Certificate of Appropriateness

2251 N. LAKE DR.

Description of work

PTS ID 60334 COA

Photos F & G - North side chimney requiring new cap and 6 courses of bricks

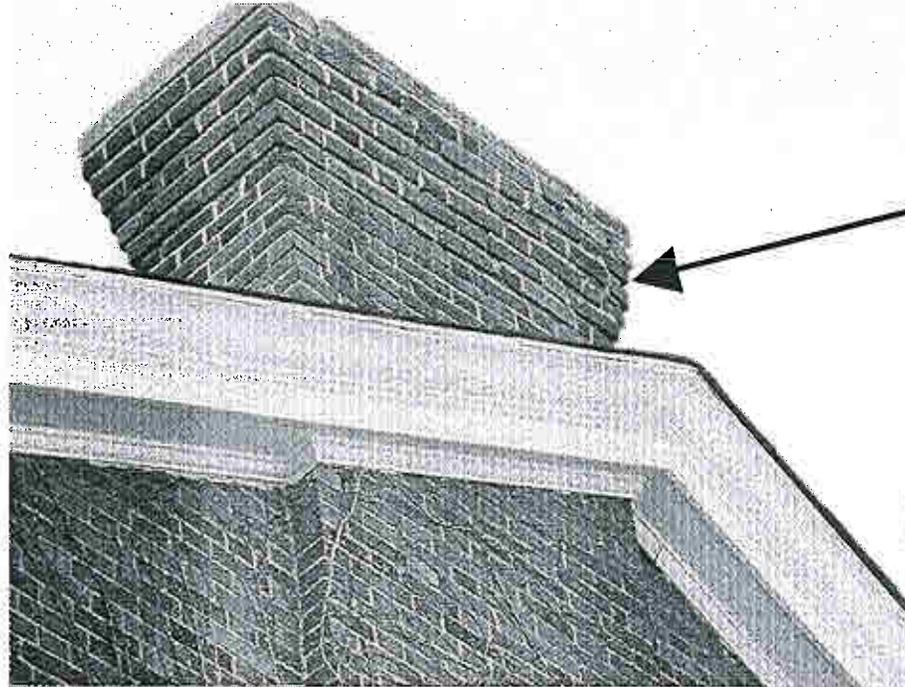
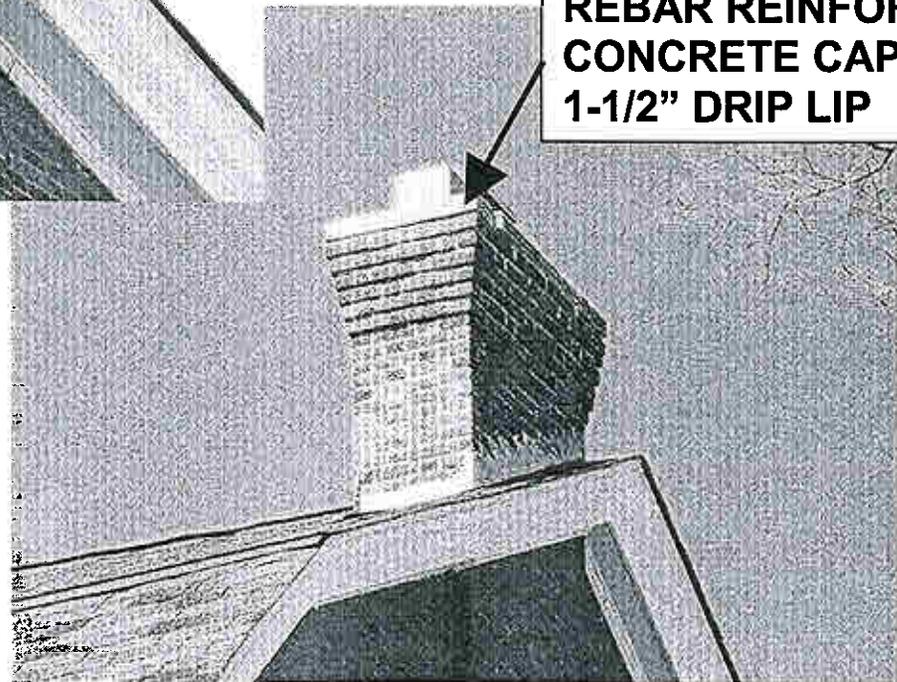
CHIMNEY SHALL BE REBUILT USING THE SAME CORBELING TECHNIQUES AS ORIGINAL. WHEN MORTAR JOINTS ARE REPLACED OR TUCKPOINTED, THE SAME STRENGTH, COLOR, AND PROFILE SHALL BE USED

REBAR REINFORCED CONCRETE CAP WITH 1-1/2" DRIP LIP

Photo A – Front of home partially obscured by tree

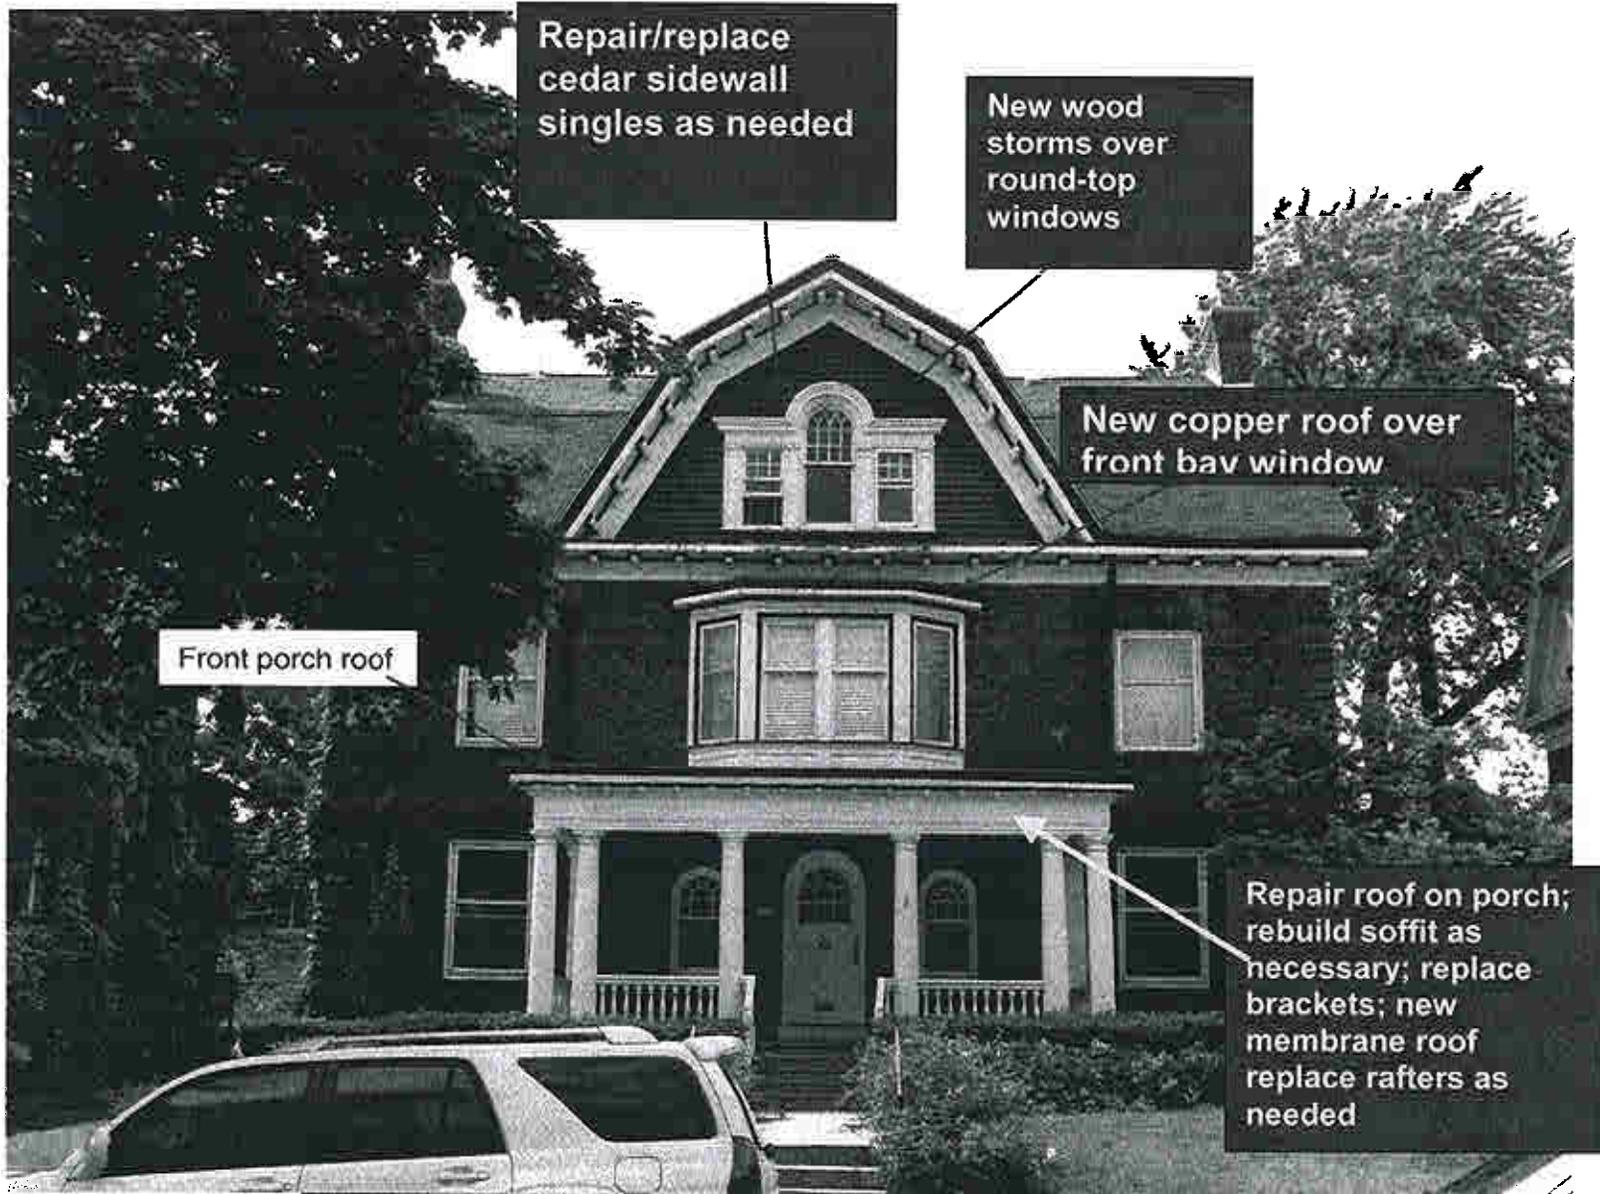
New built-in copper gutters as needed; repair/replace wood soffit with matching new, clear wood and paint it when

Chimney on rear of house may be tuckpointed, and new mortar must match the building's original mortar in terms of joint width, finish and texture. If new brick are used, they must match the original brick in terms of color, texture and size.
